SUMMARY OF CONCERNS IN RELATION TO THE PROPOSED NORTHCONNEX TUNNEL

This is an objection to many aspects of the proposed NorthConnex tunnel.

SECTION A: THE CONNECTIVITY OF NORTHCONNEX SOUTHERN VENTILATION FACILITY AT THE SOUTHERN INTERCHANGE, THE SOUTHBOUND TUNNEL IN PARTICULAR

Figure 5-17 Motorway operations complex

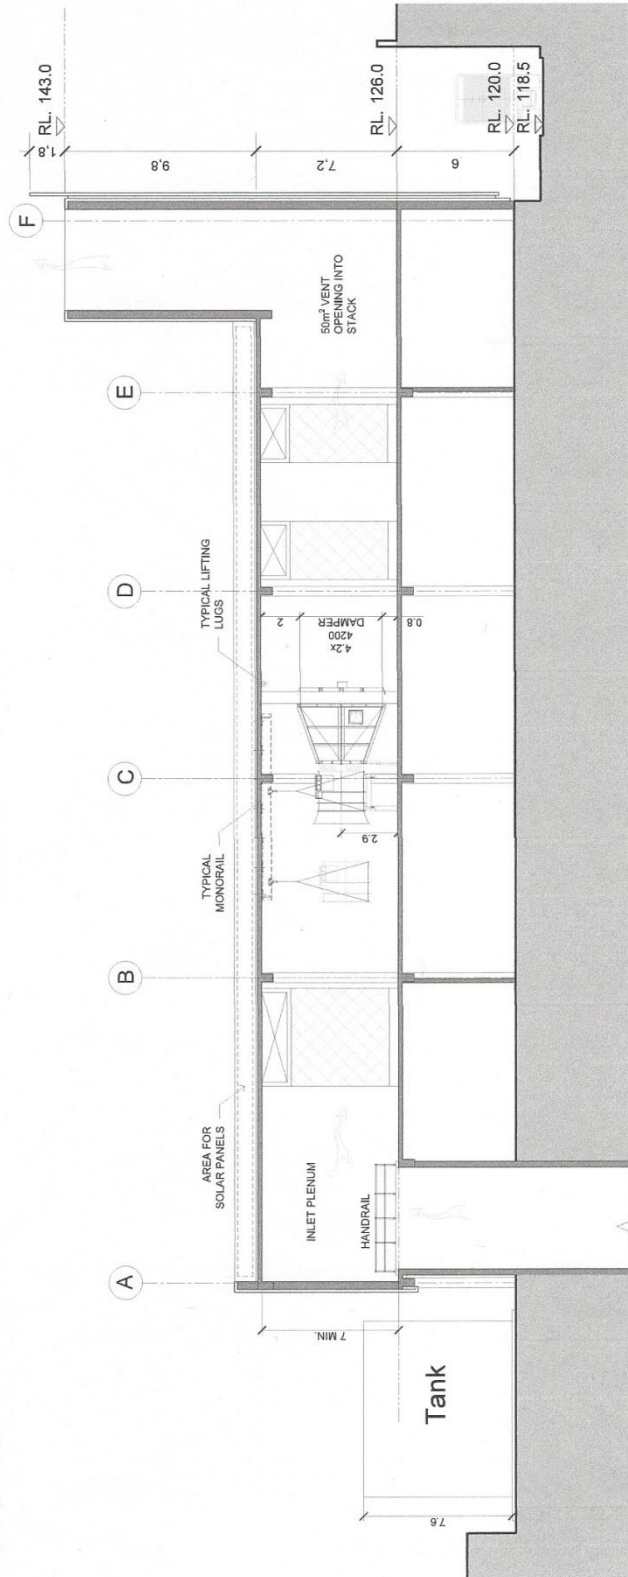
EIS Page 111, *Figure 5-17 Motorway operations complex*

Page 8 below there is no indication of how the ventilation facility will be connected to either the northbound or southbound tunnel, nor is there any indication of how the southbound exit portal onto Pennant Hills Road or the south-west exit portal onto the M2 will be connected.

MOTORWAY OPERATIONS COMPLEX - SOUTHERN VENTILATION FACILITY - SECTIONS
M1-M2-5000-DR-JD-0525

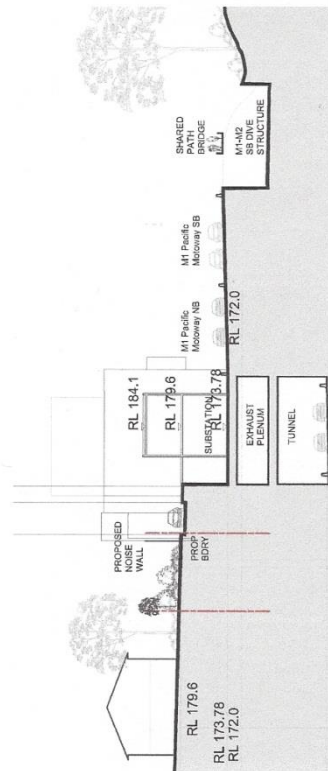
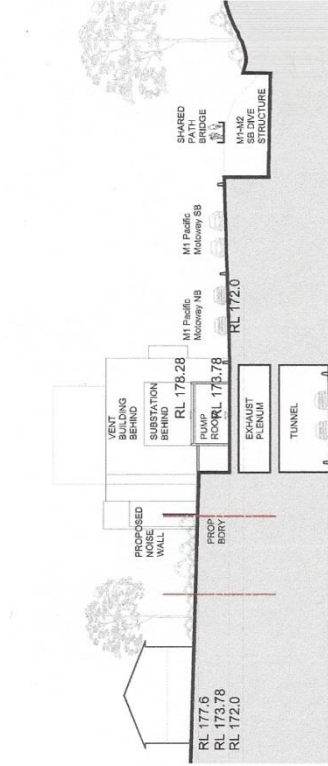
5. *EIS Volume 4, Technical working papers - Urban Design, 6.0 Operational Ancillary Facilities*
EIS Page 99 there is the diagram "Motorway Operations Complex – Southern Ventilation Facility – sections. *Page 10 below* The diagram has the cryptic label "Connection to tunnel TBC". What does TBC stand for? To be considered? Why is tunnel singular? Which tunnel is the diagram referring to northbound or southbound? There is no diagram showing any connection from the Southern Interchange ventilation facility to either the northbound or the southbound tunnel in any way AND YET

6. *EIS Volume 4, Technical working papers Urban Design, 8.0 Landscape Design*
EIS Page 176 is the diagram "Motorway Operations Complex – Southern Ventilation Facility – Site 1-1". *Page 13 below* The diagram does not show any connection to either the northbound or southbound tunnel. In the same Landscape Design section, EIS Page 182 is the diagram "Wilson Road Tunnel Support Facility –Section" *Page 14 below* which clearly shows the connection to the tunnels. In the same Landscape Design section, EIS Page 189 is the diagram "Northern Ventilation Facility – Landscape Concept Section". *Page 15 below* This also clearly shows the connection to the tunnels.

- Diagrams need to be provided showing the inter-relation between the shaft, the ventilation outlet and the motorway operations centre with a clear description of what is to be constructed and how it will operate.
- The community needs irrefutable evidence that the polluted air from the southbound tunnel exit portals will not be allowed to flow like an invisible sewer through West Pennant Hills, North Rocks, Carlingford and Beecroft.

M1-M2-5000-DR-UD-0550
NORTHERN VENTILATION FACILITY - CROSS SECTIONS

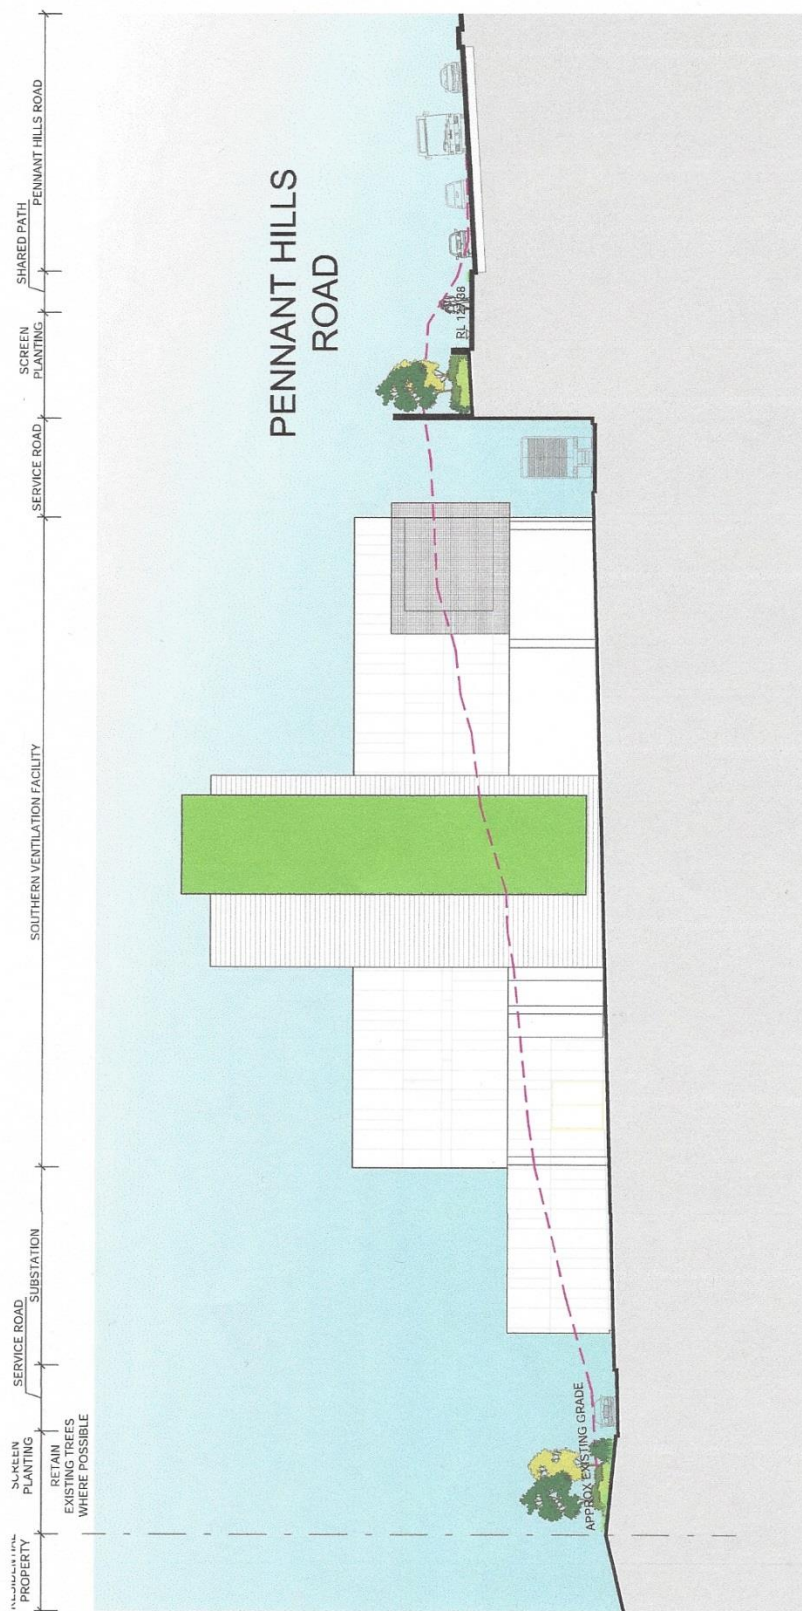
EIS page 135 *Page 11 below* there is a very explicit diagram showing the *Northern Ventilation Facility – cross section*.

Why are there no comparable diagrams for the Southern Interchange and the Southern Ventilation facility?

M1-M2-5000-DR-UD-0556
NORTHERN VENTILATION FACILITY - LONG SECTION

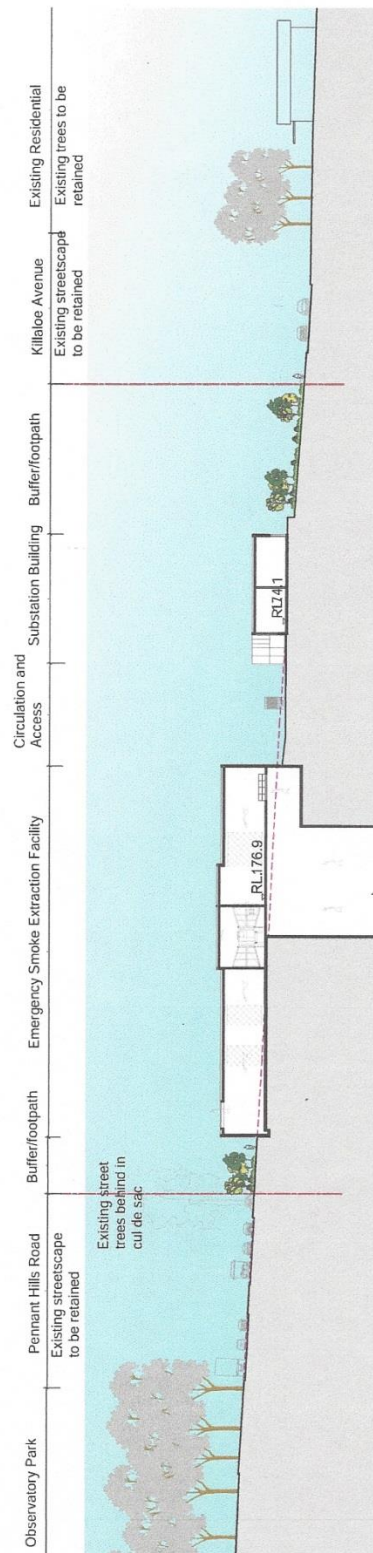
EIS page 134 *Page 12 below* there is a very explicit diagram showing the *Northern Ventilation Facility – long section*.
